Standard Life's plans to upgrade the track network at Ralia and the Cairngorms National Park

## **Description**

Map from planning application showing location of road upgrades and ATV tracks. Grey = deep peat. The other colours show outline proposals for tree planting and the land bought by Standard Life.

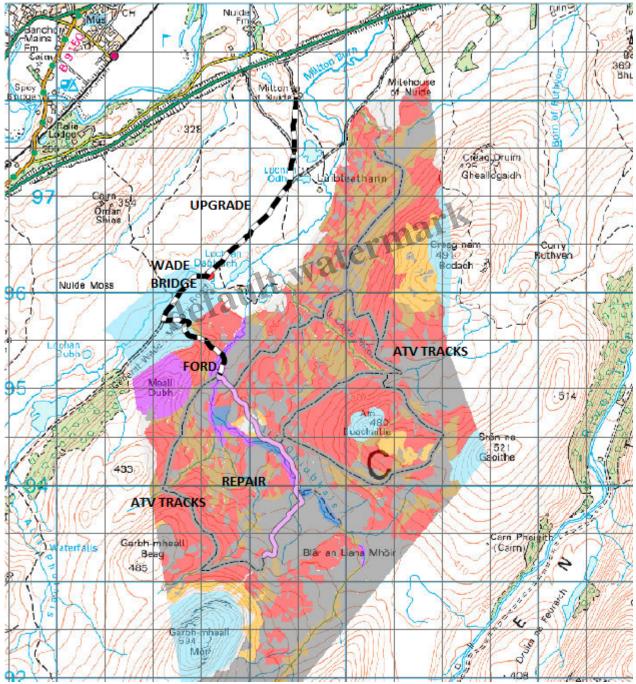
SAC's justification of the upgrade is mince. There is no need for vehicles that are heavier than 4 x 4s to plant trees and the proof of that lies in the supporting statement and the map above. ATVs, not heavy vehicles, will be used to transport trees across the site. The firefighting equipment argument is also nonsense as the 3.5m wide upgrade ends shortly after entering the proposed woodland planting area, meaning that the vast majority of the site would remain inaccessible to fire engines. As for the health and safety and comfort of the people planting trees, modern vehicles have such good suspension that tracks like this pose few issues. SAC consulting should be far more worried about workers on ATVs disappearing into the areas of deep peat crossed by the proposed ATV tracks!

One possibility is that ABDN are also planning to restore areas of peatbog high up, work that normally involves heavy machinery. But if that was the case, why have they not also applied to upgrade rather than repair the higher section of track? Moreover, the map indicates that ABDN are planning to plant this area of bog with trees which, while seriously damaging it releasing large amounts of carbon into the atmosphere, won't require use of heavy vehicles.

Nor does it consider the impact that the ATV tracks are likely to have on the peat bog. While the routes of the proposed tracks <u>mostly</u> avoid areas of "deep peat", they will cross other areas with peaty soils and this will damage the vegetation. That might not matter too much if the tracks were only "to aid in the initial works to establish the woodland" and the vegetation was then allowed to recover. But the ATV tracks are also for "deer control and site maintenance", in other words intended as permanent.

"General plan" orientated to match

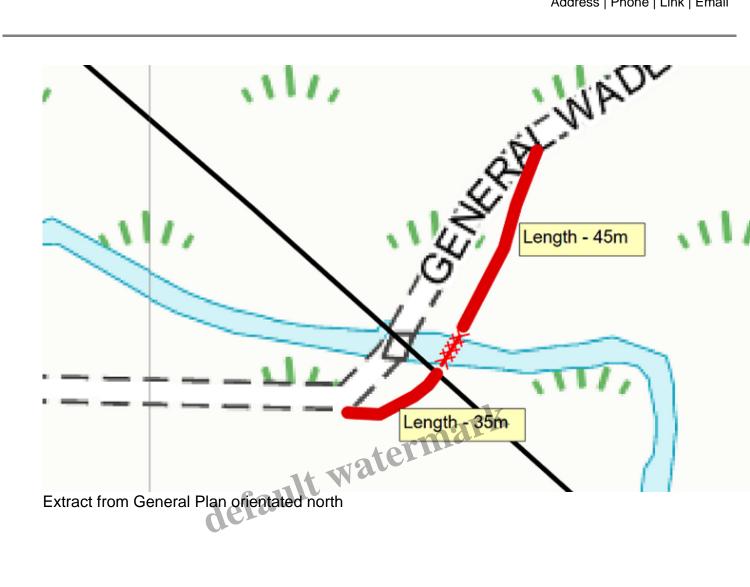
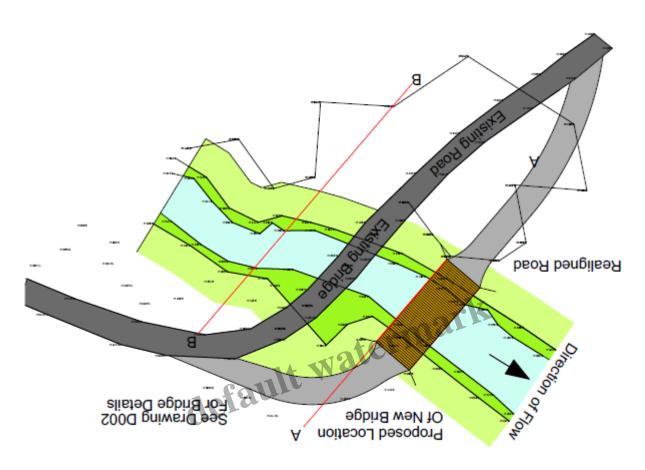
Moreover the plans are far from clear, being orientated in opposite directions

The general plan is dated 26th August and may have pre-dated the gate that has been erected across Wade's bridge but the developer should have ensured it was included in the plans they have subsequently submitted and explained its purpose.

Since trees can be planted using ATVs and landrovers, there is absolutely no justification for replacing the Wade Bridge to make it useable by heavy vehicles and this part of the proposal therefore clearly requires a full planning application.

Figure 1.1 - Existing Road Cross Section

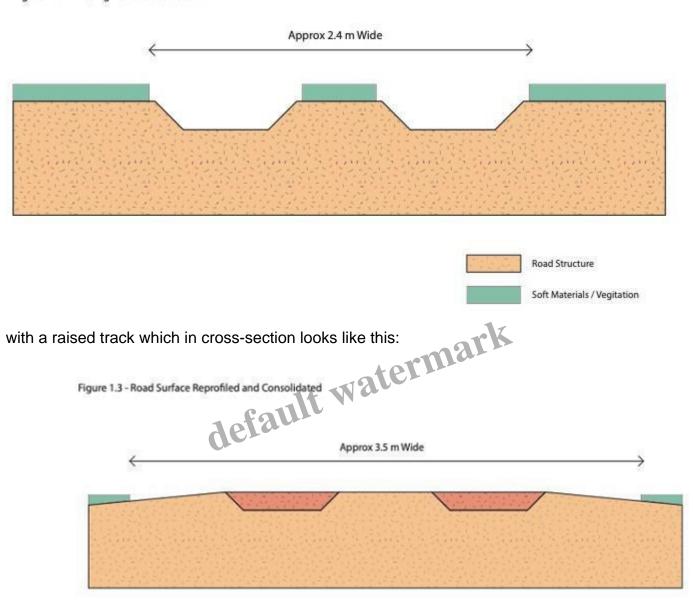
While the Supporting Statement refers to shallow drainage ditches and states "Vegetation will be reinstated on verges as required" this is not shown in the cross sections prepared not by SAC consulting but by Kilrie Trees.

There are some good arguments that raised tracks, which shed water, are preferable to other designs in some places. However, no evidence has been provided that water is causing serious problems on the existing track, possibly because it and the ground beneath it drains well.

Moreover, even if such a track could be justified here, it is too wide, there are no proposals to cover the central strip with vegetation and the plans for the verges are vague. The supporting statement claims " Useable hard materials from the centre and sides of the road will be used to fill in established running tracks and allow water run off" but this is likely to affect a considerably wider area than shown in the diagrams as there is not enough material within the footprint of the existing track to create a new higher, broader one. How this will be restored is unclear.
